AMENDMENTS TO THE DRAWINGS:

The attached replacement sheet of drawings includes changes to Figs. 12-13. The replacement sheet, which includes Figs. 12-13, replaces the substitute drawing sheet including Fig. 12-13 that was submitted on *May 24, 2002*.

Fig. 12

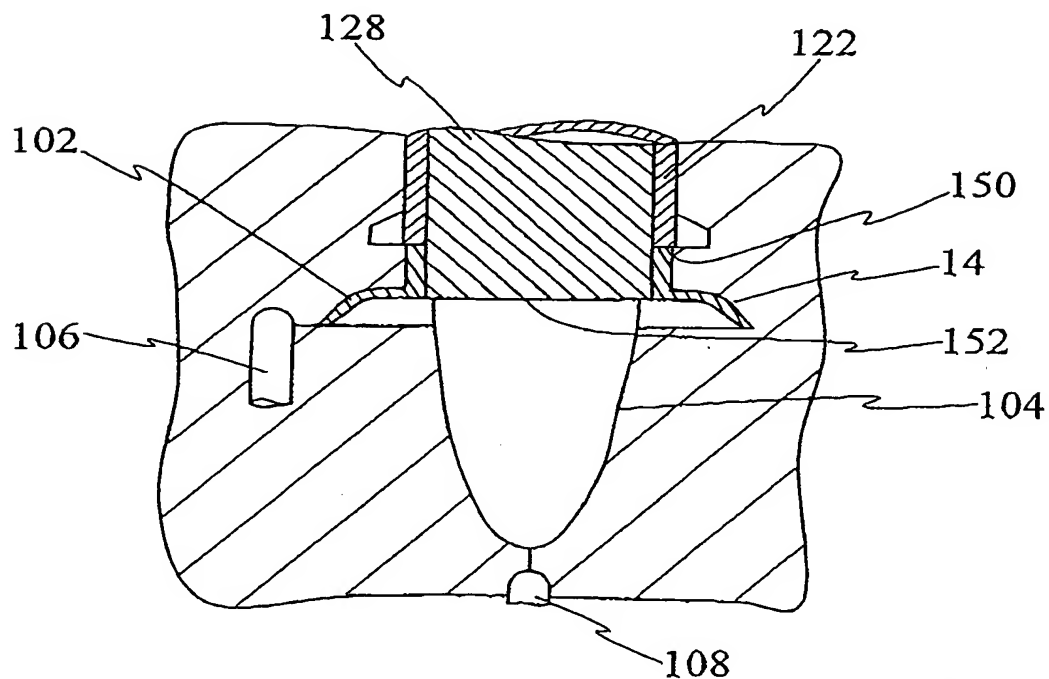
FIGs. 12 and 13 have been amended to show the correct configuration of FIGs. 12-13 originally filed on March 4, 2002, in the manner kindly suggested by the Examiner in paragraph 4 of the Office Action.

In particular, in FIGs. 12 and 13, seal 14 and collar 76 are now shown with the same hatched lines so as to indicate the same material.

In FIG. 12, bottom 152 is now shown to close off gap 138.

In FIGs. 12-13, seal 14 has been amended so that it does not extend under core surface 152 to be consistent with FIGs. 5-6.
